To customers installing CD-1A to VF80

<Correction on VF80 owner's manual>

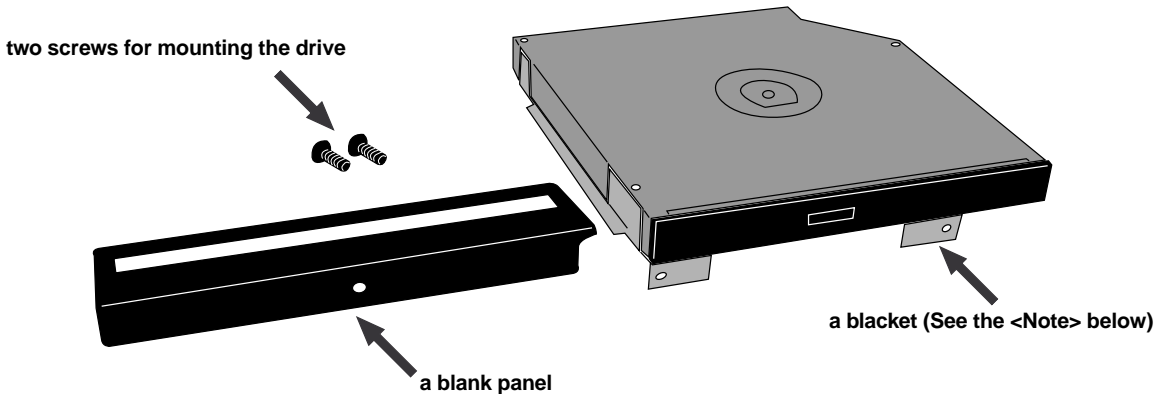
When installing Model CD-1A into VF80, the bracket attached to the bottom side of CD-1A, the blank panel and 2 x screws shown in the drawing below are not required to use. Refer to the page 135 - 136 of VF80 Owner's Manual for removing the bracket and installing Model CD-1A.

After removing the bracket indicated by the arrow in the above drawing by loosening 2 x screws, **DO NOT** put them back to the CD-1A holes where they were originally mounted. Otherwise, the tip of the screw touches the tray internally to disable tray eject.
